IEEE P802.15 Wireless Personal Area Networks

| Title | TG3 D10 running comment resolutions | |
| Abstract | [This document is a record of comment resolutions for LB17.] | |

Figure 119 – MSC for reserving asynchronous data channel time. Discussed earlier, new MSC is below:

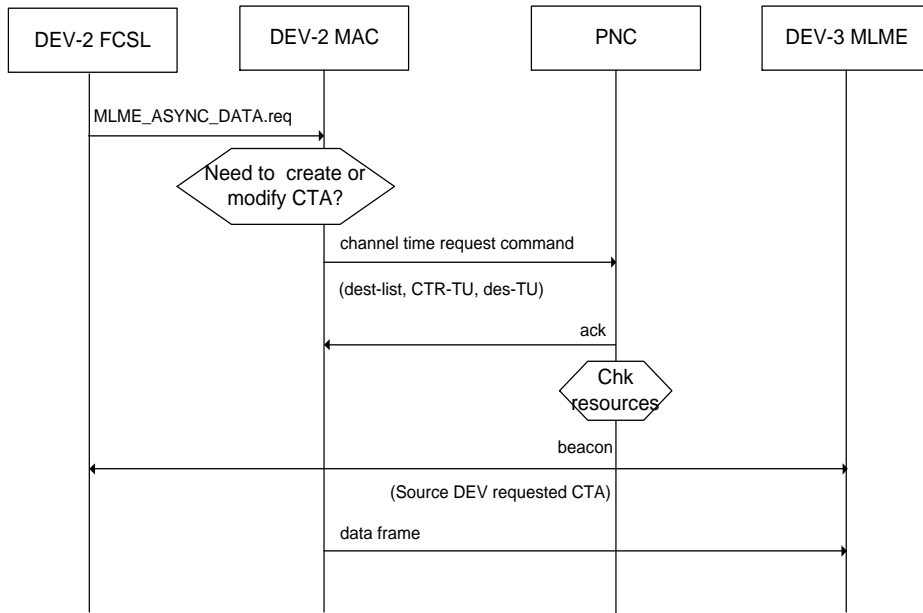
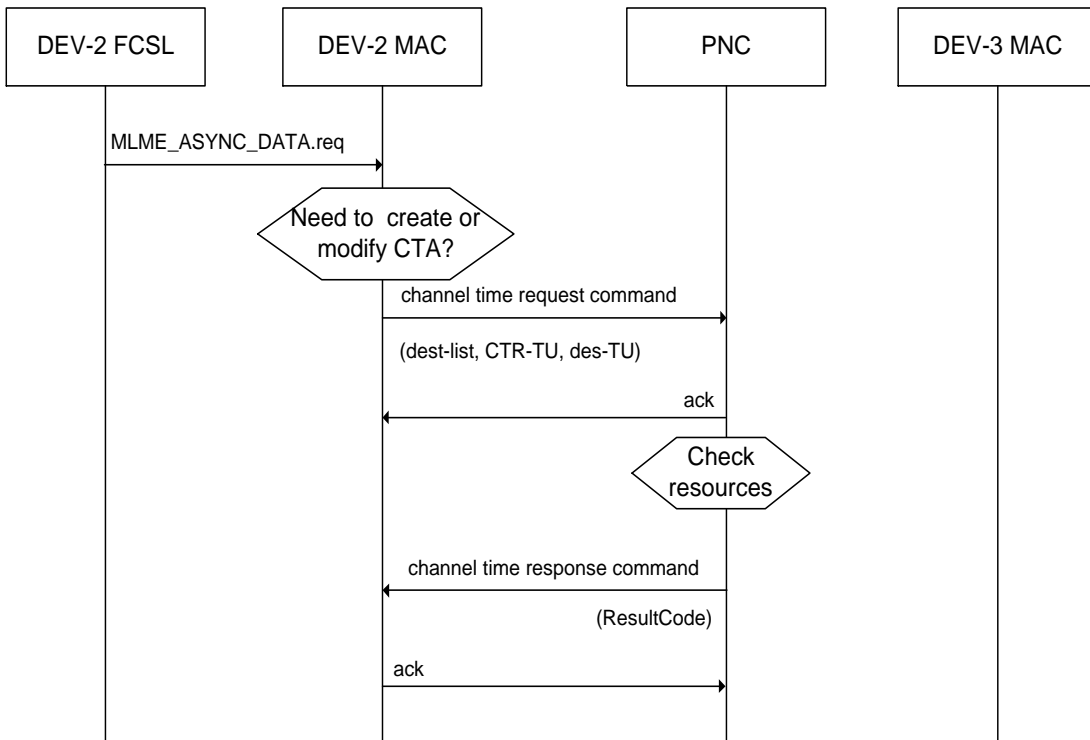
614, 652 (Gilb, T) The MLME-CREATE-CTA.req should be shown coming from the DEV-2 DME. What is "MAC-Q"? Also, the CL is no longer the packet CL but the FCSL (i.e. frame convergence sublayer). Consequently, change MAC-Q to be simply MAC. Change Packet CL to be FCSL in figure 4. **Accept in Principle** 1) replace MAC-Q and MLME with simply DEV-2 MAC. 2) Rename Packet CL to FCSL 3) Delete Figure 4 since it is duplicated in Figure 119. 4) Incorporate suggested changes identified in CID 327

914 (Bain, T) In figure 119, The PNC DME has the task of building the beacon. However, in the isochronous operation figures, the PNC MLME is shown to be building the beacon. Consequently, change the location of the build beacon element to the PNC MLME. **Suggest accept in principle** per CID 327

327 (Heberling, TR) Figure 119 is a flawed MSC of the Asynchronous channel time reservation process and data frame exchange. Consequently, delete the current MSC from this section of clause 8.5.2.1 and replace it with 02r0P802-15_TG3-Asynch-channel-time-allocation.eps. **Suggest accept**.

Figure 1—MSC for a approved asynchronous channel time request

Figure 2—MSC for a denied asynchronous channel time request
